Development Application **ACCESS REPORT**

Reference Number: 22461

Site Address: 84 Brook Street, Muswellbrook NSW

This Access Compliance Report is to accompany a Development Application (DA) for the development proposed at **84 Brook Street, Muswellbrook NSW**

[Image description: Plan of Ground Level above shows the provision of Accessible parking spaces]

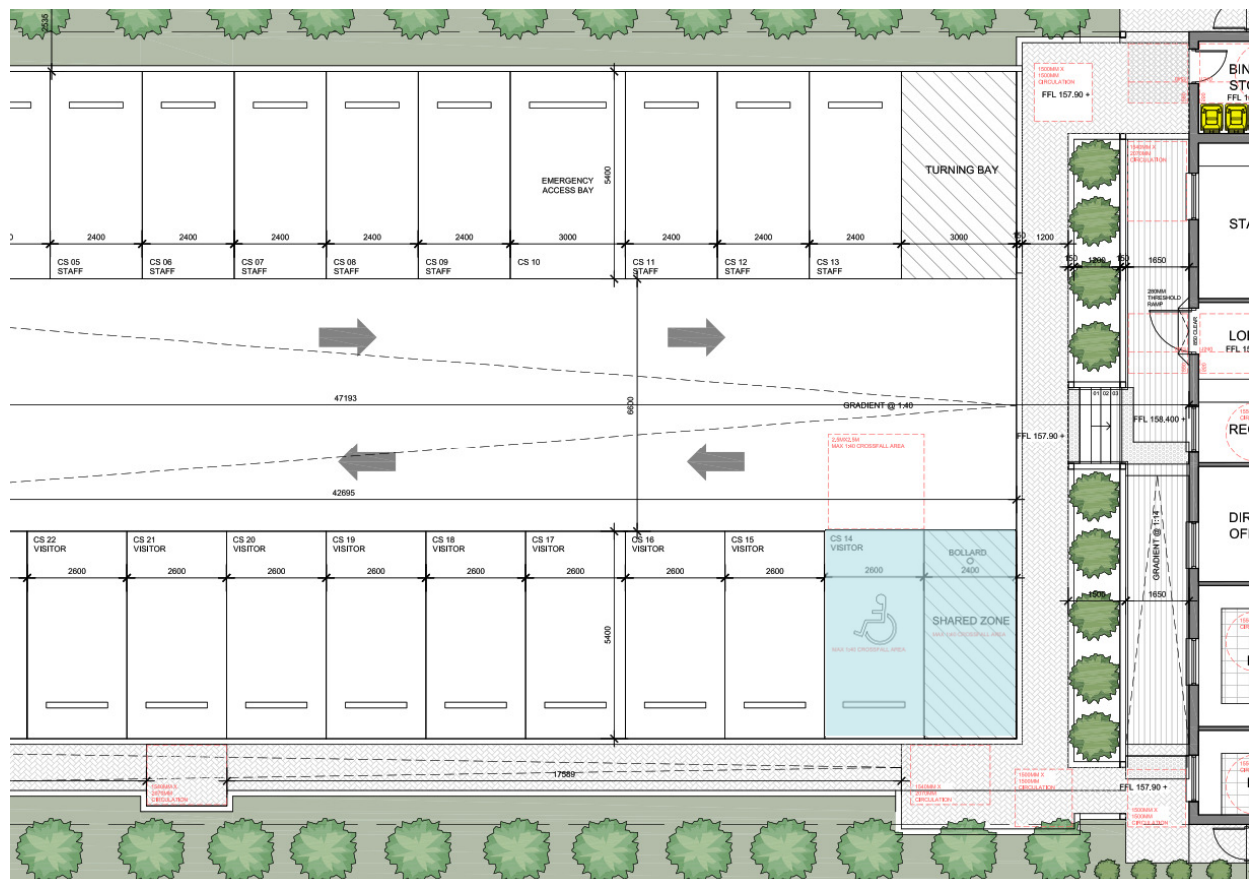
- School - 1 Accessible car parking space per 100 spaces provided
- Other assembly building - 1 Accessible car parking space per 50 spaces provided and then additional 1 Accessible car parking space per additional 100 spaces provided

Total number of Accessible parking spaces required / provided in the development = 1
